FINAL PLAT OF
"DEER CREEK ESTATES
SECOND ADDITION"
SEDGWICK COUNTY, KANSAS
(SW1/4 OF SEC. 24, T28S, R1W OF THE 6TH P.M.)

S/D 98-21 - Final Plat of VANDERHOFF ESTATES

CASE NUMBER: S/D 98-21 - VANDERHOFF ESTATES

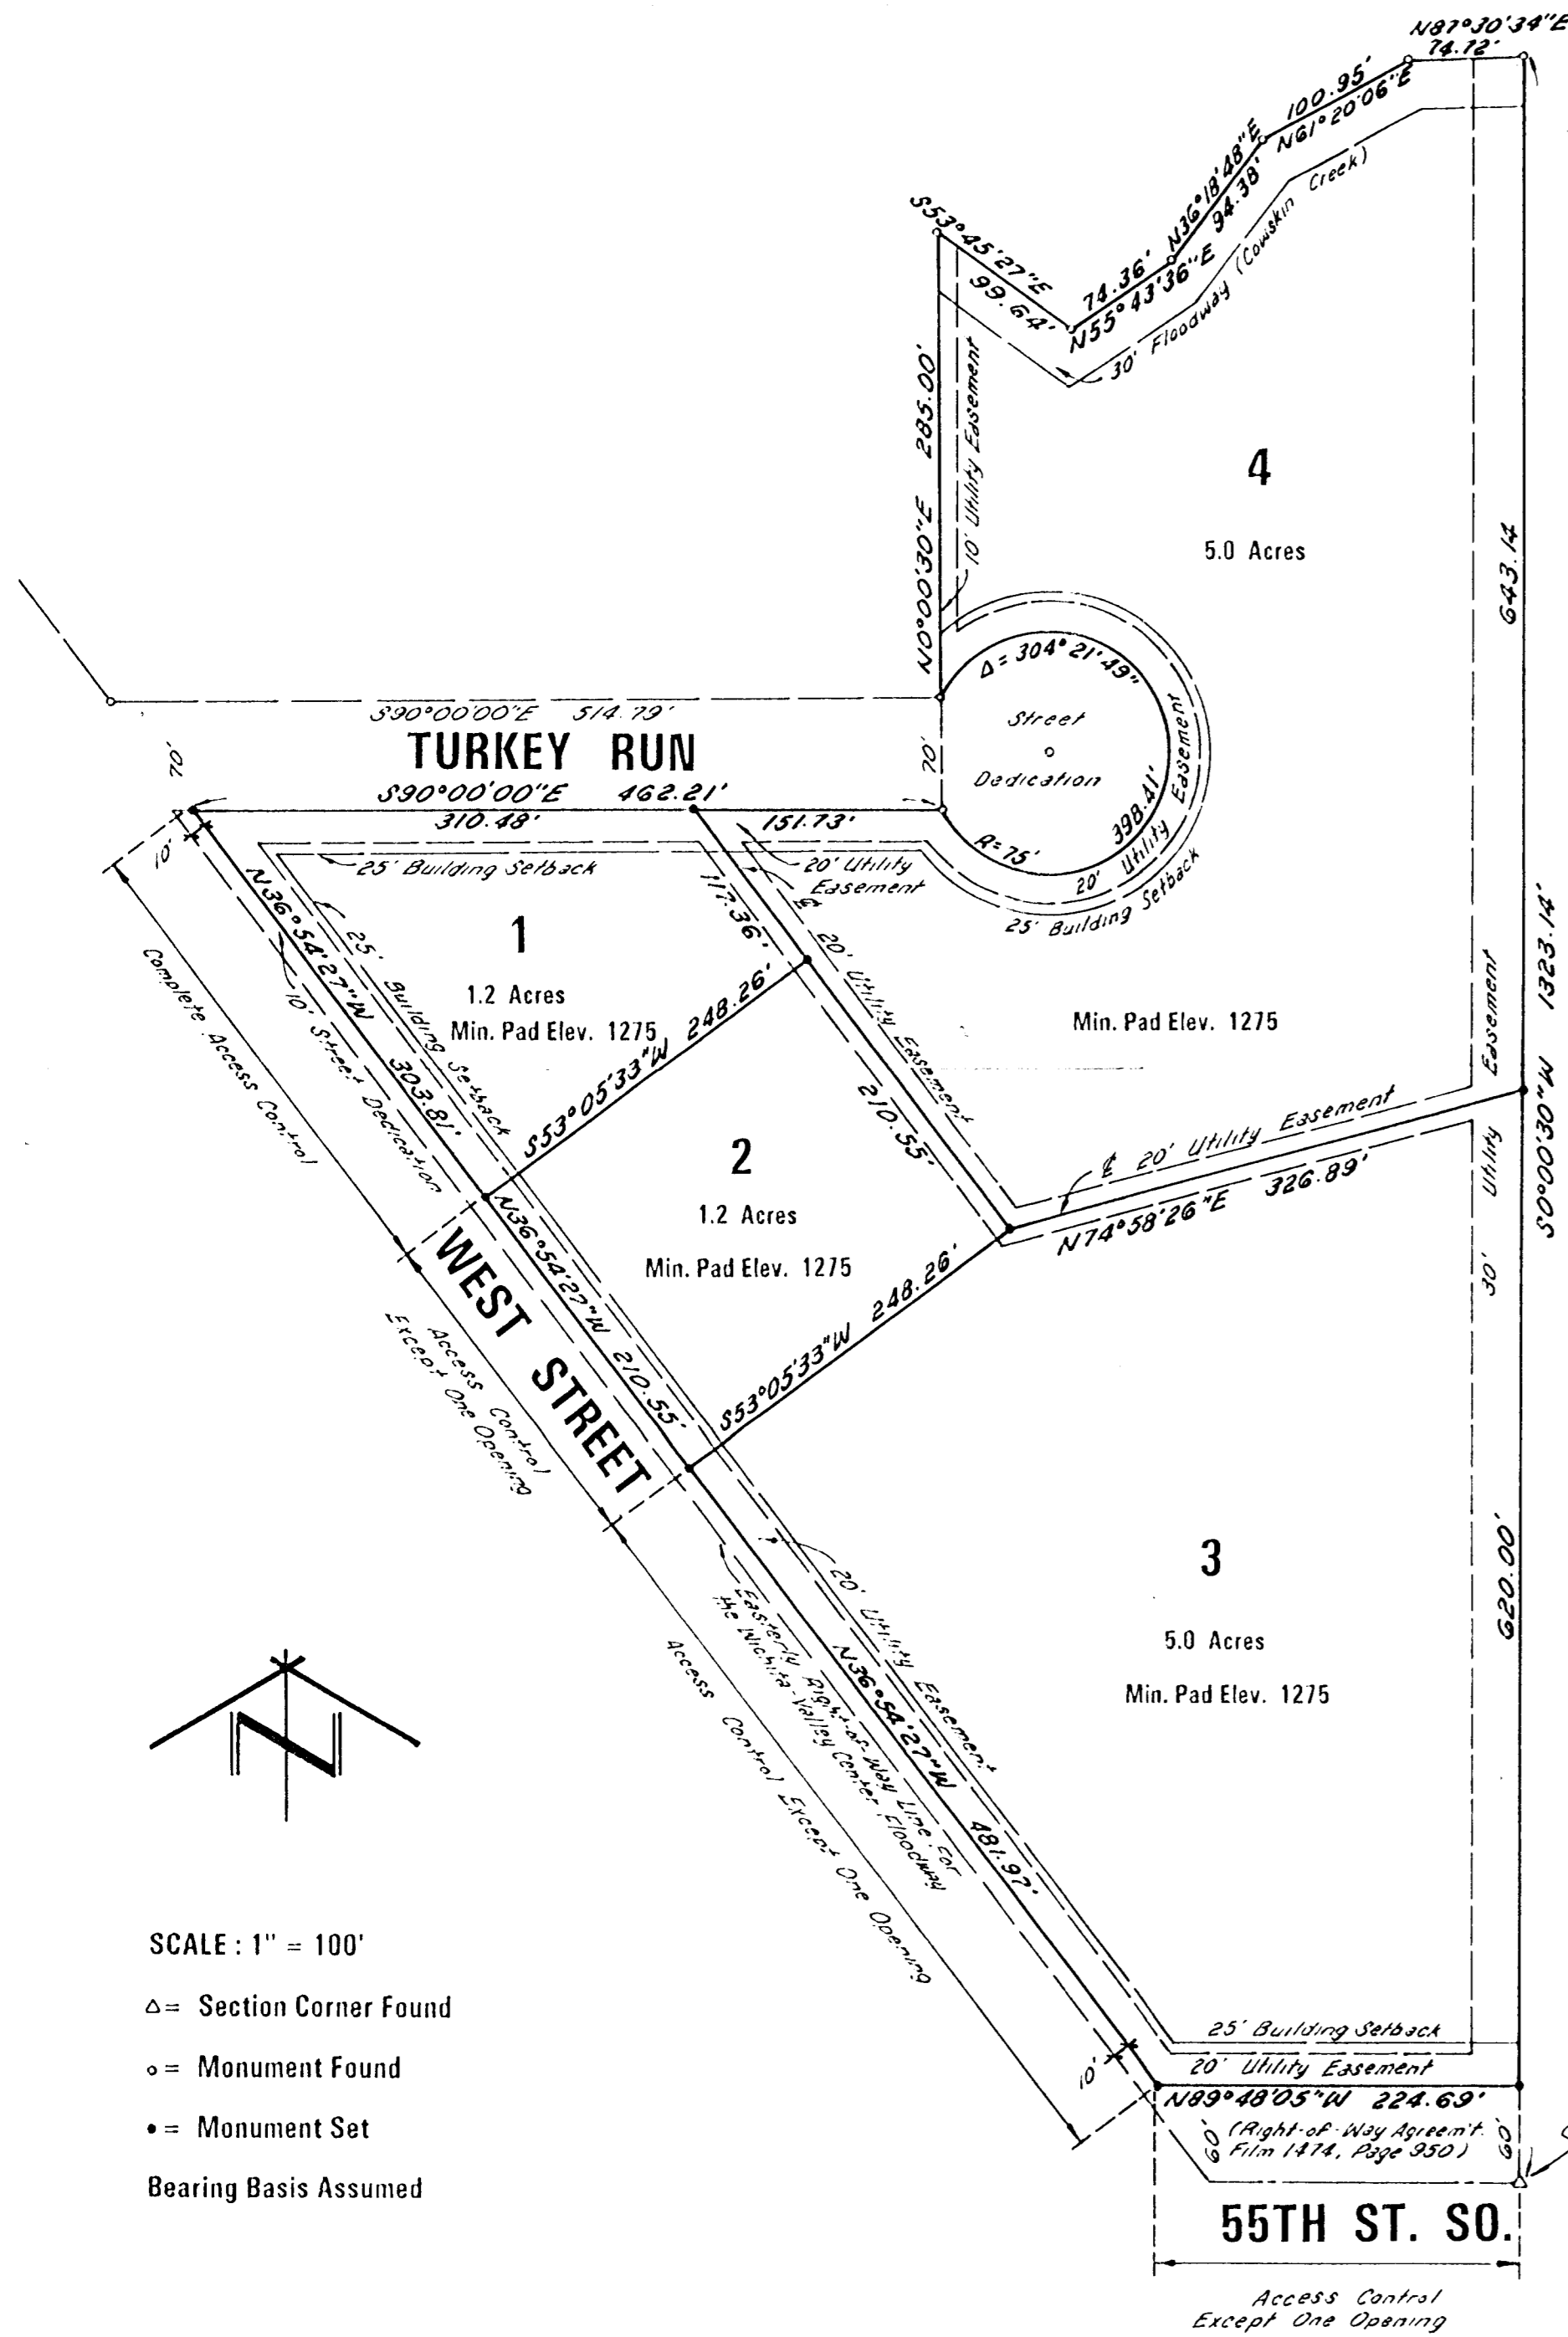
- C. **City Engineering** needs to indicate the status of Wichita water and sanitary sewer service for this area and what guarantees need to be provided at this time. **Guarantees will be required for future City water and sanitary sewer. An easement for future location of sanitary sewer needs to be denoted on plat.**

- E. **County Engineering** needs to comment on the status of the applicant's drainage plan. *The drainage plan has been approved.*
- F. *County Engineering and MAPD recommends dedication of access control along West Street except for one opening each for lots 2 and 3. Access to Lot 1 shall be from Turkey Run. Subdivision Committee approves said openings in addition to an opening from Lot 3 to 55th Street South per applicant's desire to maintain an existing opening.*

- H. It is recommended that the front yard utility easements are eliminated and replaced with rear yard utility easements. Overly wide utility easements (30 foot) are recommended to be platted in the rear of lots 3 and 4 to allow for the installation of utilities without damage to existing tree rows. *Subdivision Committee approved both front and rear yard easements to give developer an option of their location.*

The requested access controls have been denoted on the final plat.

The final plat denotes the requested 30-foot easement in the rear of lots 3 and 4.
